## ALEDO ISD BOARD MEETING TEMPLATE

**AGENDA ITEM:** Consider Approval of Contingency Allowance Expenditure Authorizations for 2019 Bond Project Aledo Middle School

**Number:** PCO-100  
**Date:** 6/8/22  
**Job:** 20-0760 Aledo MS Addition and Reno

**Description:** PCO - 100 ASI 10 Bearcat Den

Job No. 01865-01-01  
Sheet No. ASI 10  
Drawn By: E.J. AB  
Date: 05/11/2022  
A2.7

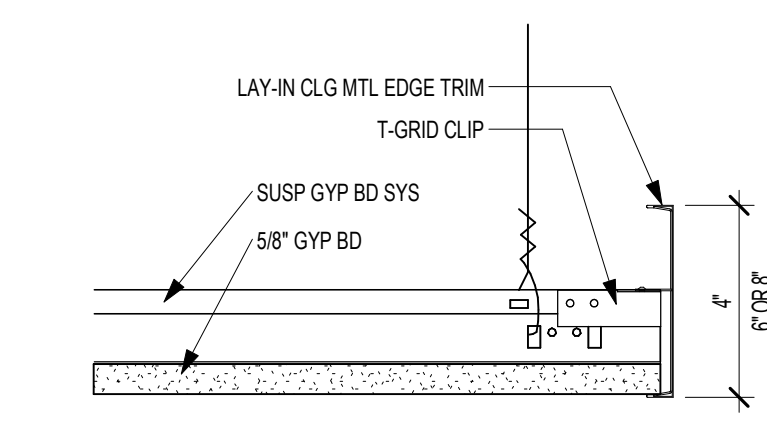
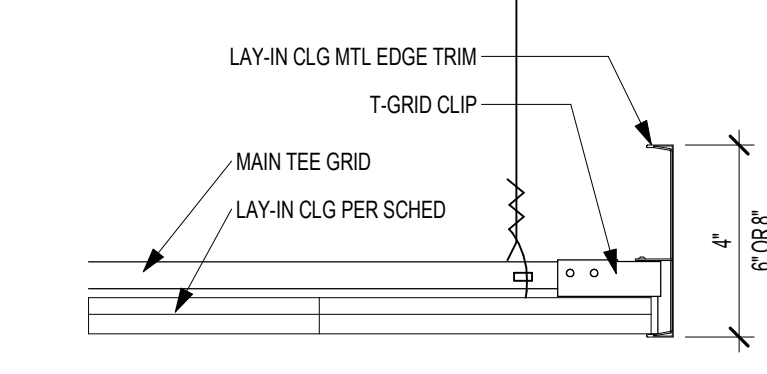
- ALL LIGHT FIXTURES - WHETHER EXISTING OR NEW IN OFFICE 7.07, PLATFORM 7.713, CAFETERIUM 7.714 AND CORRIDOR 7.746 TO RECEIVE FIRE BLANKET.
- ALL HVAC DUCT WORK - WHETHER EXISTING OR NEW IN OFFICE 7.07, PLATFORM 7.713, CAFETERIUM 7.714 AND CORRIDOR 7.746 TO RECEIVE FIRE RESISTANT INSULATION.
- ALL HVAC DUCT DEFUSERS - WHETHER EXISTING OR NEW IN OFFICE 7.07, PLATFORM 7.713, CAFETERIUM 7.714 AND CORRIDOR 7.746 TO RECEIVE FIRE DAMPERS.
- ALL PENETRATIONS IN FIRE RATED CEILING AND WALL ASSEMBLIES TO BE FIRE CALLED WITH WHITE FIRE CALKING.
- MAXIMUM FIXTURE PENETRATION - 1 HOUR RATED CEILING: 24 SQ IN 100 SQ FT (OFFICE 7.07, PLATFORM 7.713, CAFETERIUM 7.714 AND CORRIDOR 7.746)
- MAXIMUM DUCT PENETRATION 1 HOUR RATED CEILING: 222 SQ IN 100 SQ FT (OFFICE 7.07, PLATFORM 7.713, CAFETERIUM 7.714 AND CORRIDOR 7.746)
- NO PENETRATIONS ALLOWED IN EXISTING TECTUM PANEL DECKING.

1	1/15/21	Addendum 1
2	2/19/21	ASI 01
4	03/12/21	ASI 03
8	05/20/22	ASI 10 Ceiling Changes - Cafeterium/7.714

**5** SECTION DETAIL - SKYLIGHT SHAFT WALL @ CAFETORIUM 7.714 - 1 HOUR  
1 1/2" = 1'-0"

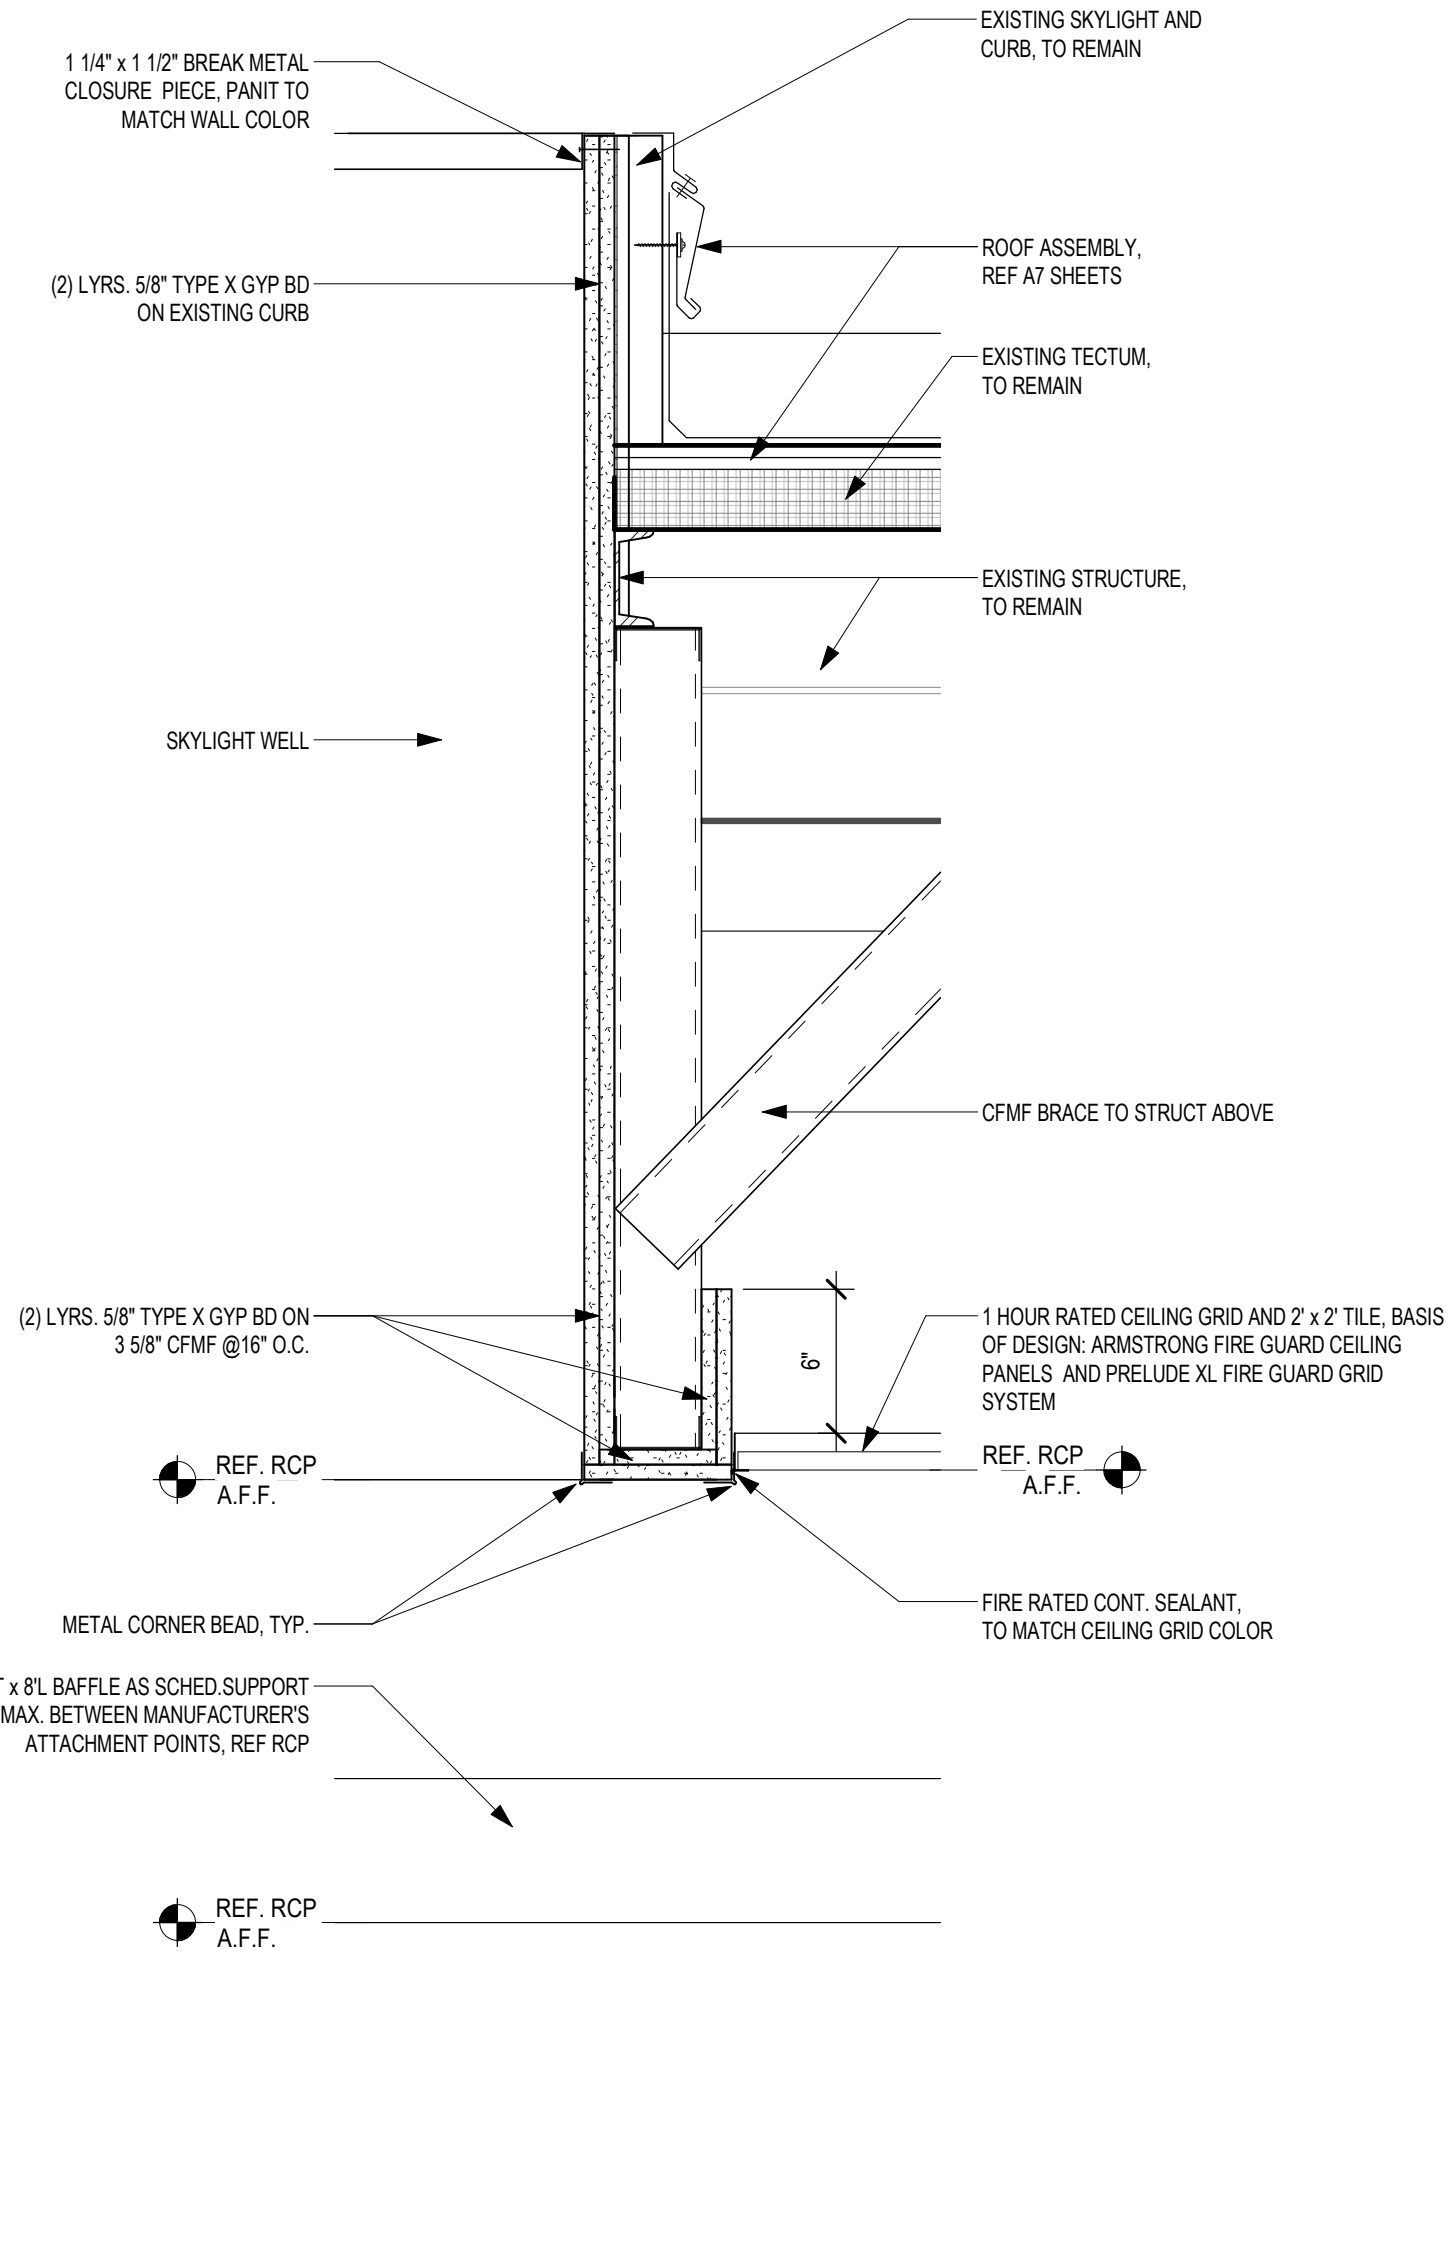
Add Fire Rated Grid/Tile @ Cafetorium  
Add Furrdowns w/ 2 Lyr Sheetrock @ Cafetorium  
Add Furrdowns w/ 2 Lyr Sheetrock @ Skylights  
9Wood Baffles are still to be installed below grid/tile ceiling

**3** SECTION DETAIL - BEAM WRAP @ CAFETORIUM 7.714 - 1 HOUR  
1 1/2" = 1'-0"

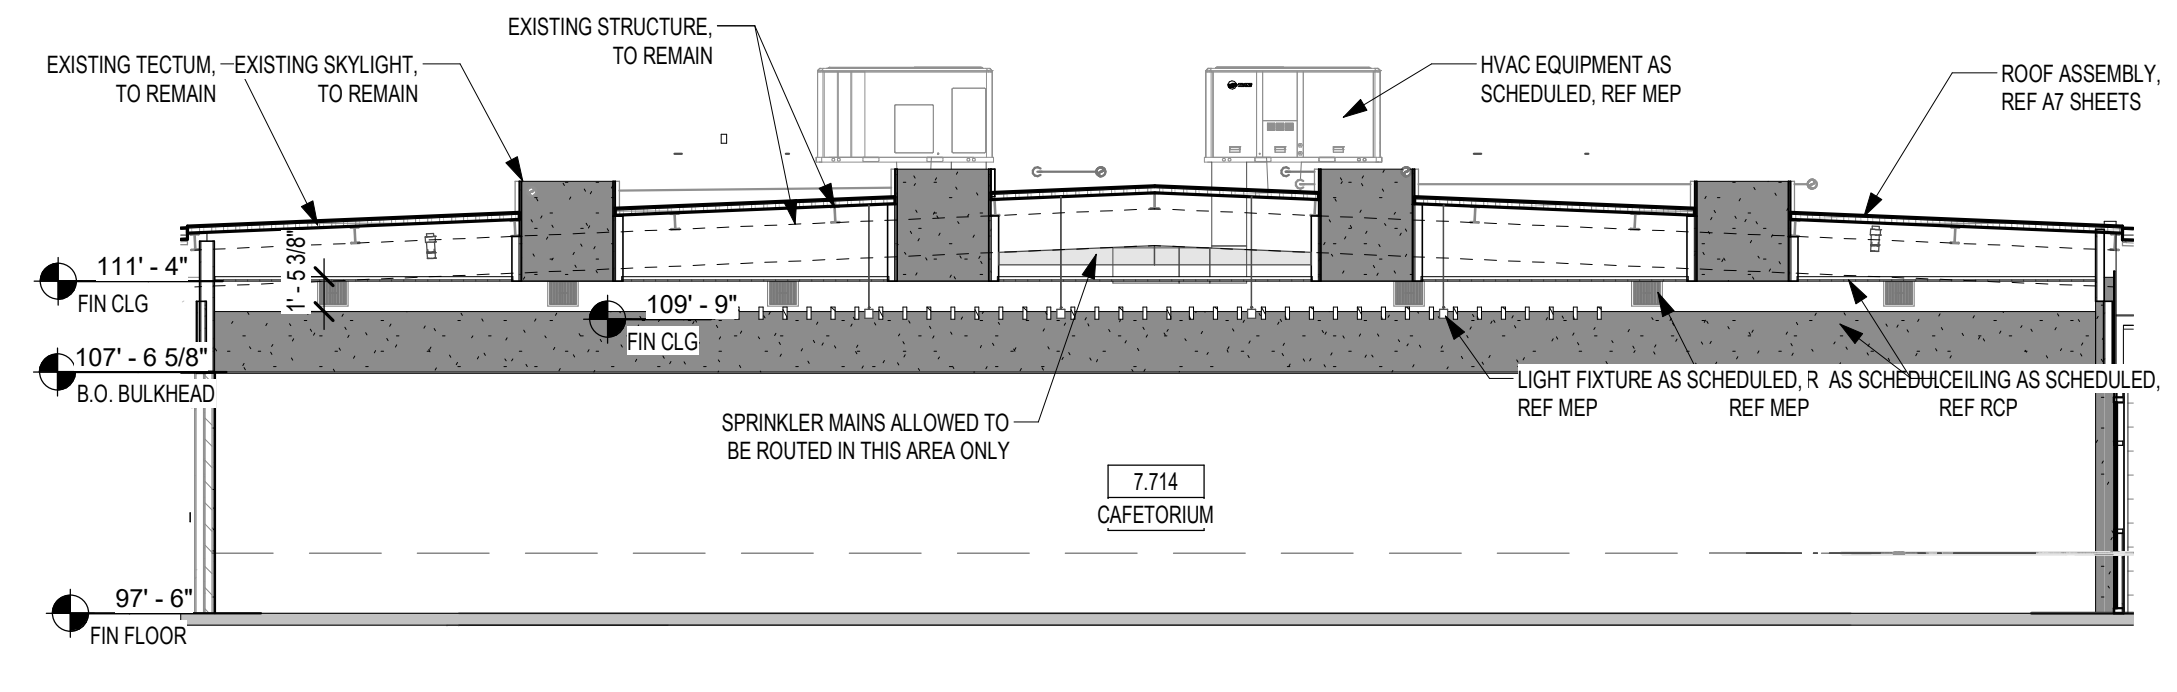
Description	Labor	Material	Equipment	Subcontract	Other	Price
Temp Handrails Allowance				\$5,000.00		\$5,000.00
Beam wraps, skylight shafts, and fire rated grid and tile.				\$114,585.00		\$114,585.00
Fireproofing credit				\$-16,240.00		\$-16,240.00
Fire duct wrap, and rated mechanical devices.				\$45,481.21		\$45,481.21
Fire sprinkler reconfiguration and material.				\$54,376.74		\$54,376.74
Texas Scenic structure change for lay in ceiling				\$5,893.00		\$5,893.00
Sheetrock prep and paint				\$7,670.40		\$7,670.40
Steel reinforcing of roof structure				\$10,811.00		\$10,811.00
Fire caulk at ceiling penetrations - Allowance				\$10,000.00		\$10,000.00
Additional GC's - Dumpster - F					\$658.00	\$658.00
Additional GC's - supervision and labor - F					\$12,600.00	\$12,600.00
Owner Contingency - NF						
					Subtotal:	\$250,835.35
					<b>Total:</b>	<b>\$250,835.35</b>
